From: [Oliphant, Marc \(FTA\)](#)
To: [John Hoppie](#)
Cc: [Kay Shelton](#); [Deanna Leggett](#); [Lyssy, Gail \(FTA\)](#); terence.plaskon@dot.gov; [Bartels, David \(FTA\)](#); [Koski, Donald \(FTA\)](#); [Shoaib, Suleman \(FTA\)](#)
Subject: RE: [External] Phase F memo to file comments
Date: Monday, January 9, 2023 8:40:36 AM

The Federal Transit Administration (FTA) has reviewed the supplemental environmental documentation (Memo to File Phase F) DART submitted for the Silver Line (Cotton Belt) Regional Rail Project on December 19, 2022. In memo to File Phase F, DART proposes two project changes: (1) the Shiloh Road Layover facility - a single large facility to provide maintenance and overnight storage for multiple vehicles and; (2) the US Brass Avoidance Alignment to avoid potential environmental hazards.

SUBJECT: DART Cotton Belt Corridor Design-Build Changes: Memo to File
Phase F Plano Infrastructure Modifications

Shiloh Road Layover Facility: Site Plan

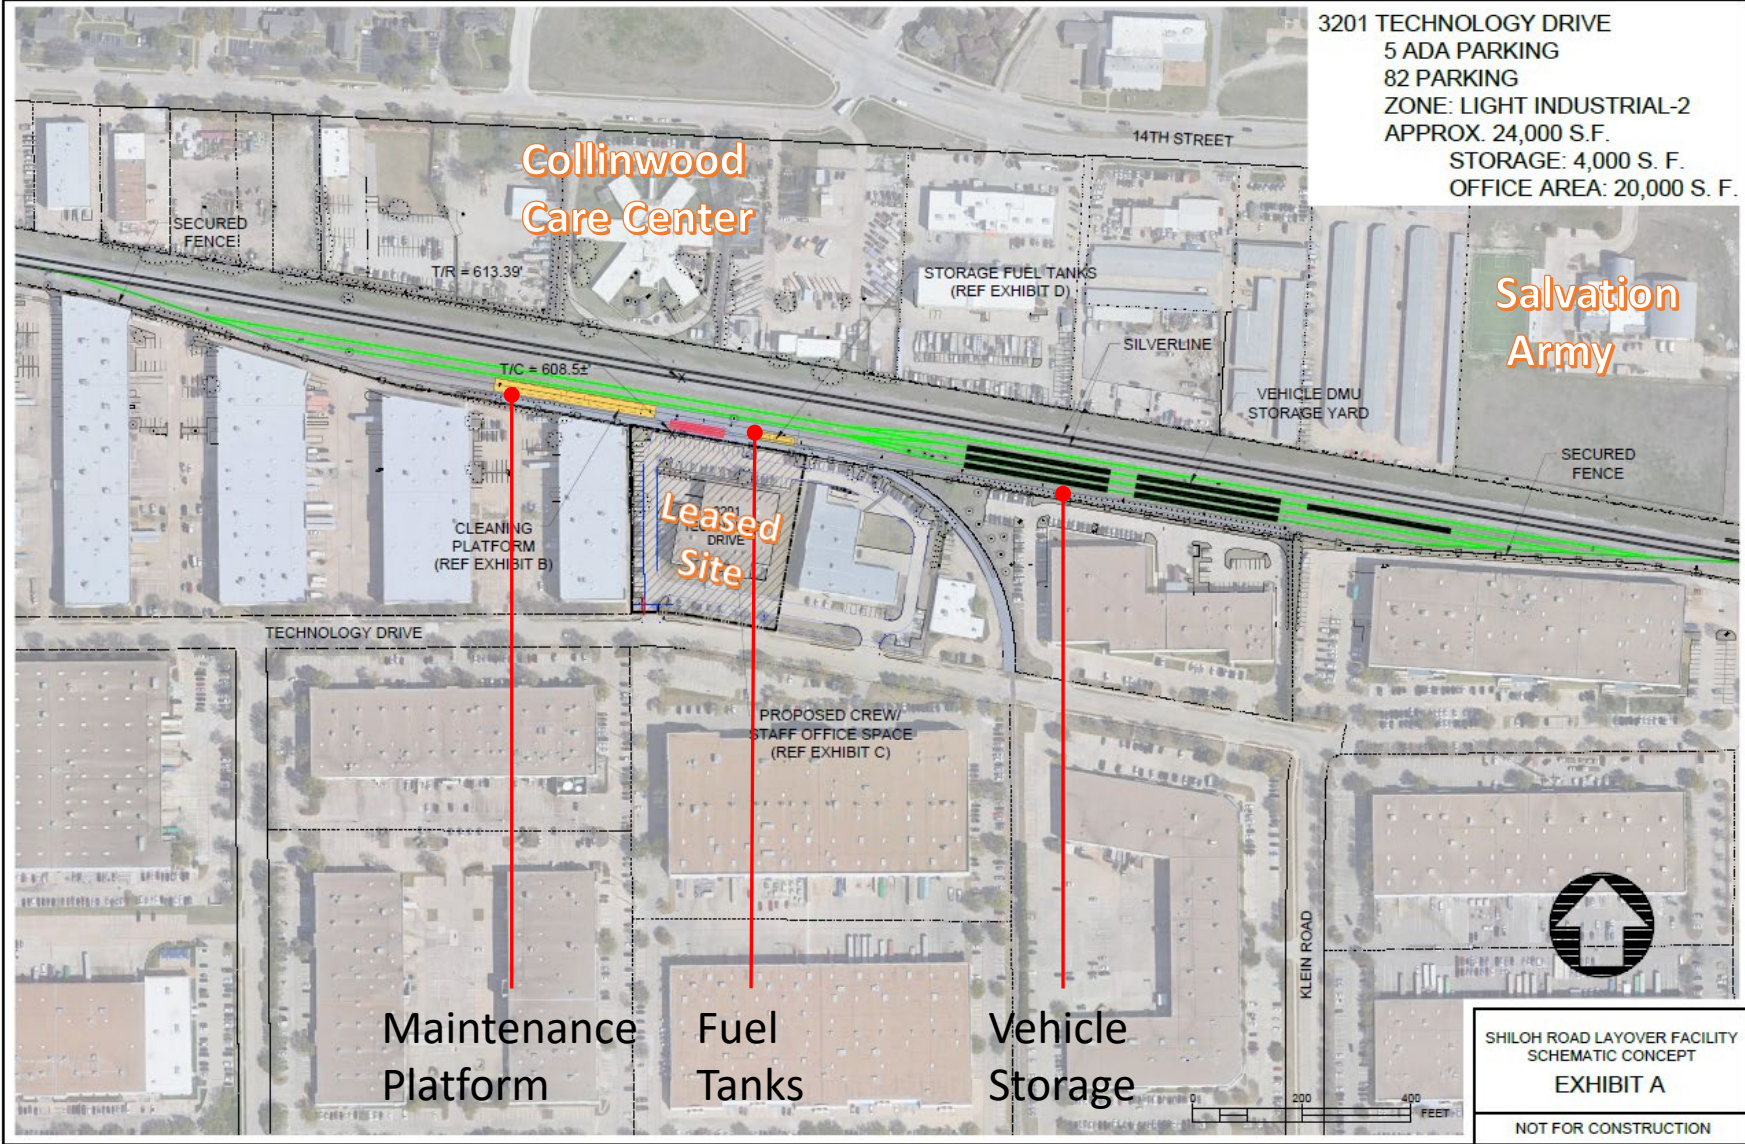
The conceptual design for the Shiloh Road Layover Facility is shown in **Attachment 2, Exhibit 3** and **Exhibit 4**. The facility could provide storage for eight Silver Line vehicles and would include a maintenance platform with an inspection pit. A canopy would cover the maintenance platform for weather protection. The facility will include two, above ground, 12,000-gallon, fuel tanks enclosed with a concrete masonry unit (CMU) wall. Refueling trucks and other maintenance vehicles would access the facility through the leased site.

Figure 1. Shiloh Road Layover Facility Site Plan

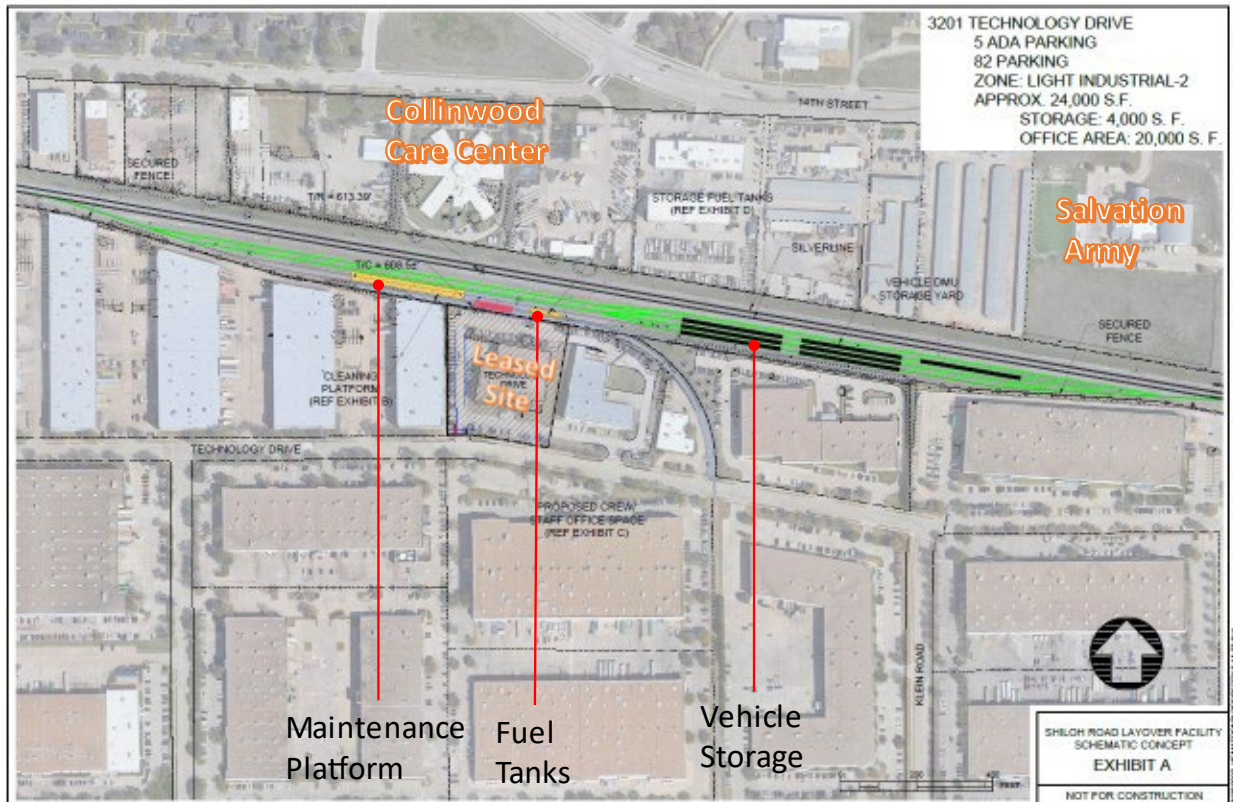
DART has identified a location immediately west of the Shiloh Road Station within the DART owned railroad right-of-way for a layover facility that was not anticipated in the DART Cotton Belt Corridor **FEIS/ROD**. As shown by the site plan in **Figure 1**, the proposed facility would include a maintenance platform, fuel tanks, and vehicle storage tracks. It is anticipated that six (6) vehicles would be located at the facility on a daily basis, with one (1) stored during peak service, three (3) stored during off-peak service and all six stored overnight. The maintenance platform would be used for daily cleaning, inspection and refueling of the Silver Line fleet of vehicles. Vehicles would operate to the cleaning platform or to a storage track and be powered down and plugged into an electric power source to avoid

As shown in **Figure 1**, the land use surrounding the layover facility site is primarily industrial, with a limited number of community facilities. The noise and vibration sensitive land uses closest to the site include the Collinwood Care Center and the Salvation Army Building, both located to the north of the Silver Line tracks. The Collinwood Care Center, a nursing and rehabilitation facility with nighttime sensitivity, is a FTA Category 2 (residential) land use. The Salvation Army Building, which houses a charitable organization and place of worship with daytime and evening sensitivity, is a FTA Category 3

Figure 2. FTA Noise Impact Assessment at the Collinwood Care Center

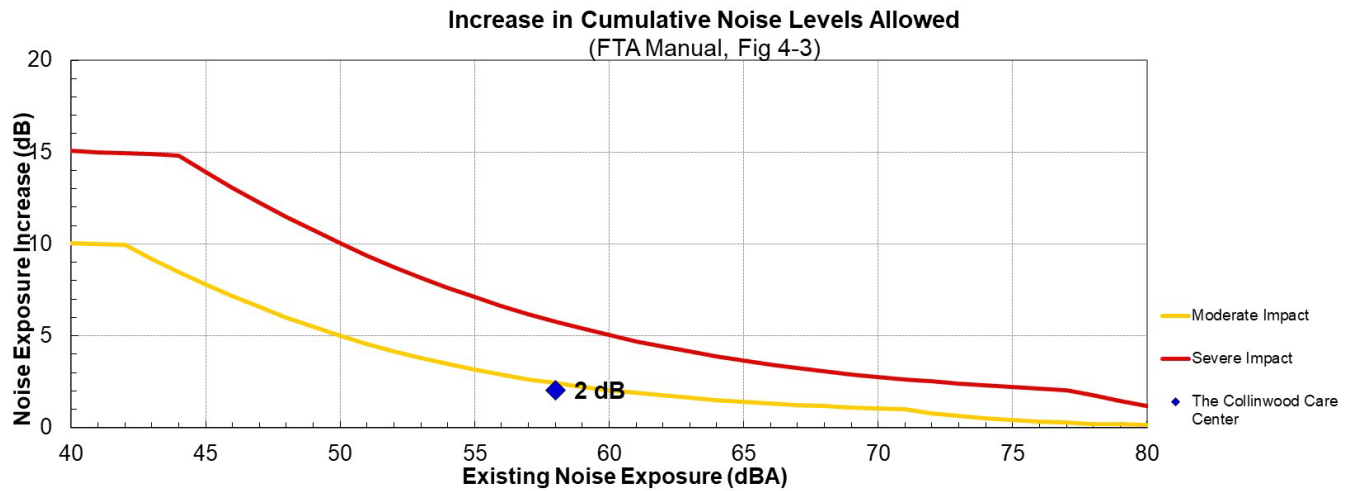
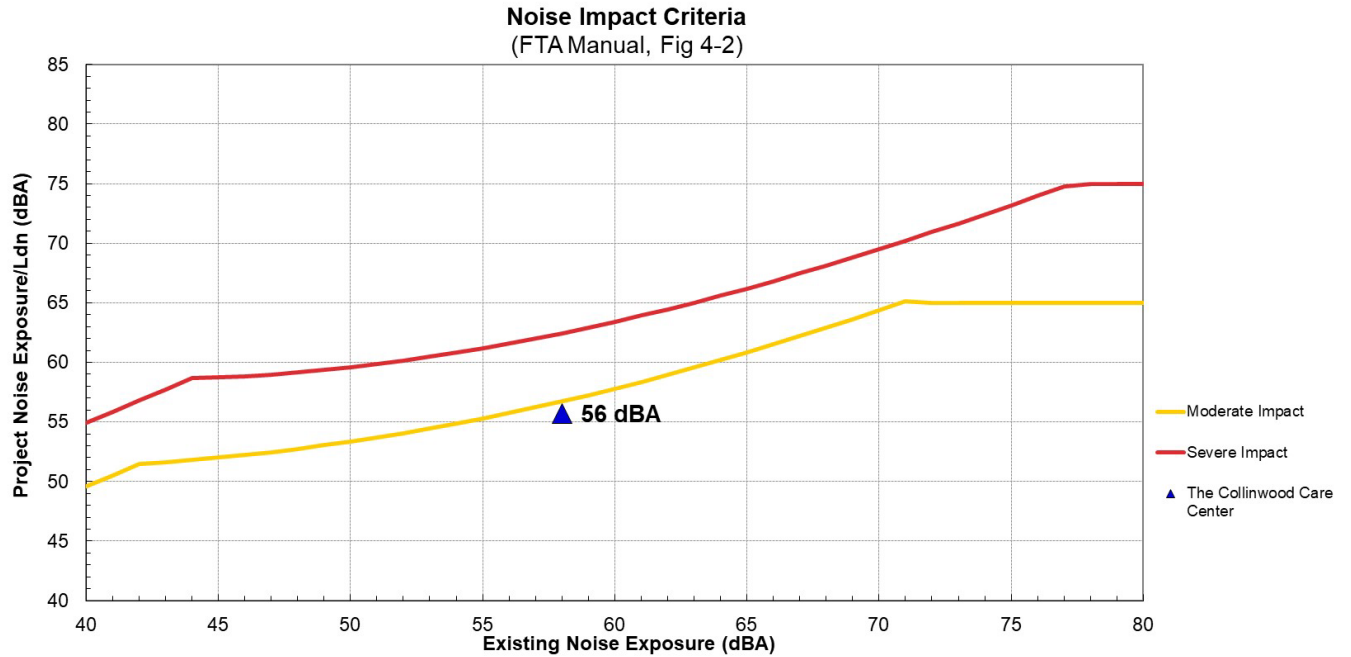
The results of the noise impact assessment are summarized in **Table 1**, and are shown graphically in **Figure 2** for the Collinwood Care Center and in **Figure 3** for the Salvation Army Building. Based on these results, it is concluded that the combined noise exposure levels from layover facility operations and Silver Line operations are predicted to be below the applicable FTA noise impact criteria thresholds. Therefore, noise impact from the project is not anticipated at any sensitive locations near the proposed Shiloh Road Layover Facility, and no noise mitigation measures are required.

CityLine Alignment North of PGBT Final Property Impacts

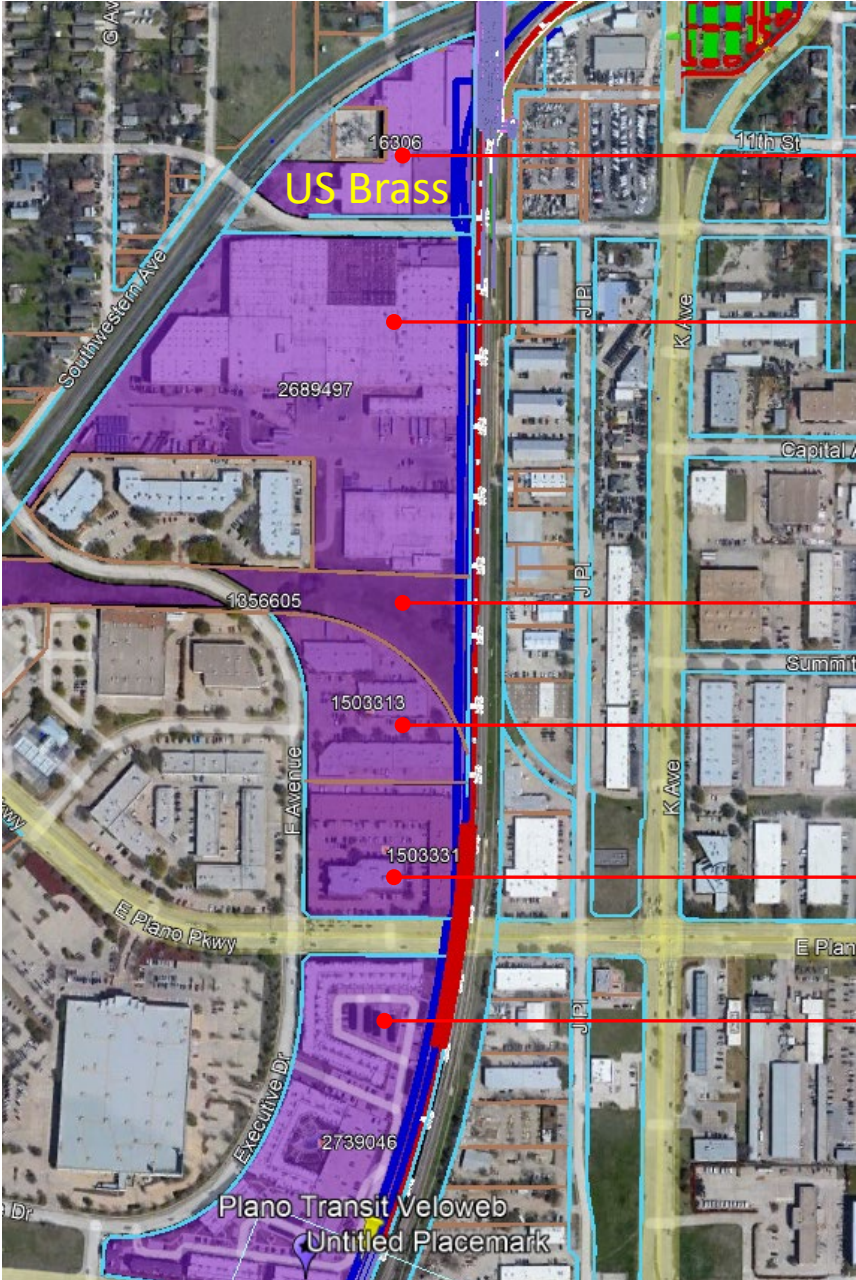
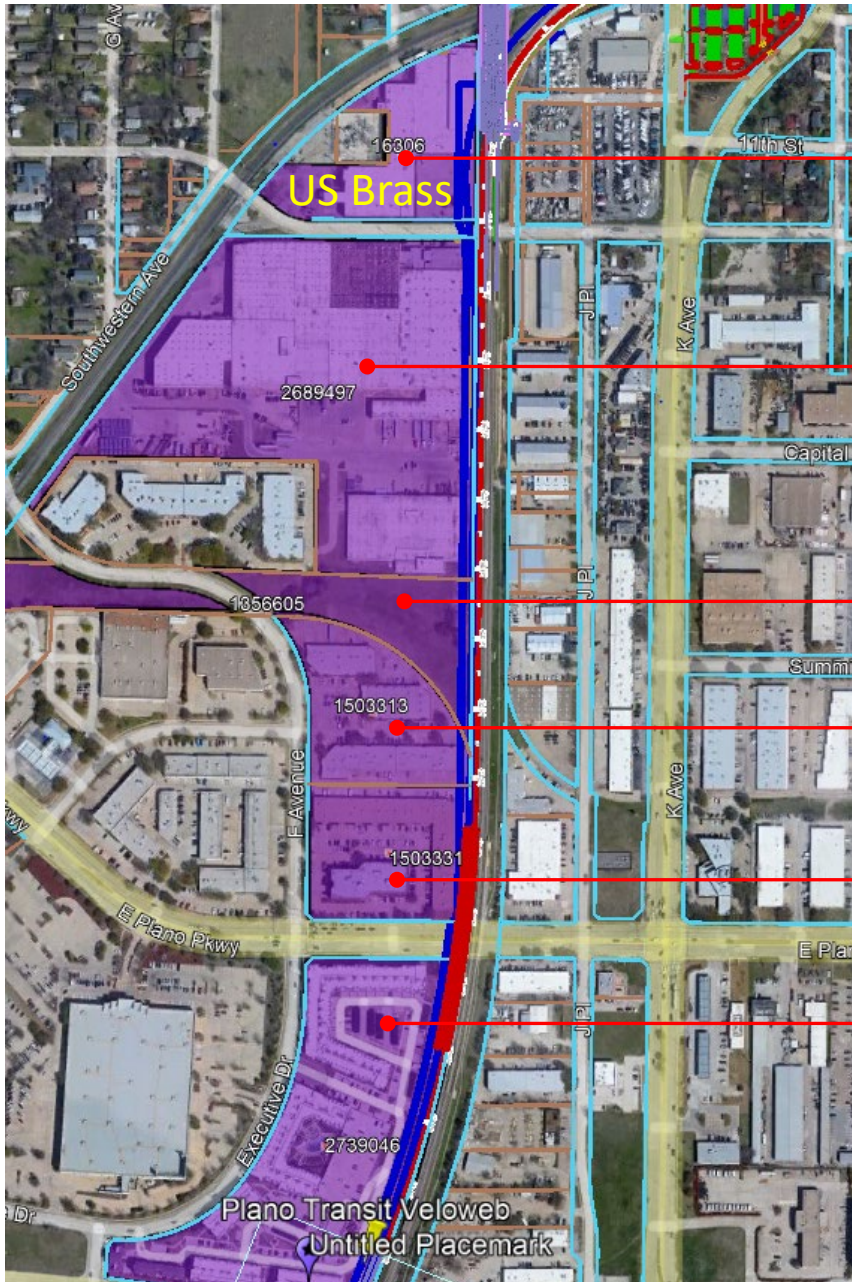
The reconfigured single-track section will result in an overall reduction in property impacts. As shown in **Attachment 3, Exhibit 3**, the six partial acquisitions are reduced to three partial acquisitions plus two utility easements. The three parcels total 20.63 acres, but only a partial acquisition of 1.71 acres is required for the project. The utility easements total 0.15 acres on two parcels. The displacement of the multi-lease building on Parcel 1503331 is eliminated as the partial acquisition is converted to a utility easement. All acquisition of US Brass Property (Parcel 16396) is eliminated.

Final Total: 3 Parcels; 1.71 of 20.63 acres; 0 displacements
plus 0.15 acres of utility easement
